The following questions relate to the circuit prioritization provided in SDG&E's partial response to MGRA Data Request Number 6:

The following questions are in regard to the following map derived from the TURN DR 6 response and MGRA analysis of SDG&E GIS data provided to WSD/OEIS. Note six instances of ignition and PSPS damage south of Ramona, only one of which is on a circuit planned for remediation.

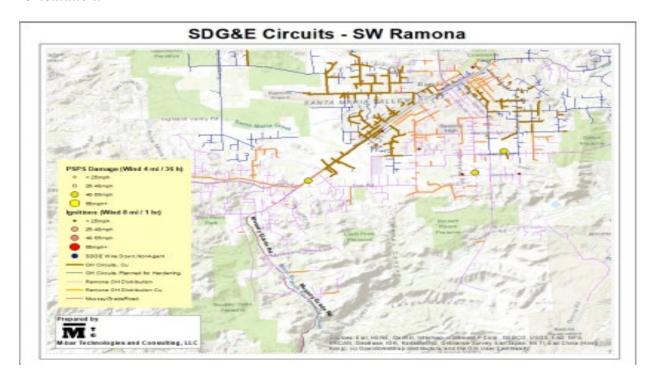
Request 5 (MGRA-44): Has SDG&E conducted extensive hardening on circuits 971 and 973? If so, what fraction of these circuits have been hardened?

Currently over half of both circuit 971 (C-971) and circuit 973 (C-973) have been hardened.

For C-971, approximately 55% of the entire circuit is hardened: 21% is undergrounded and 43% of the remaining overhead portions is traditionally hardened.

For C-973, approximately 65% of the entire circuit is hardened: 54% of the circuit is undergrounded and 24% of the remaining overhead portions traditionally hardened.
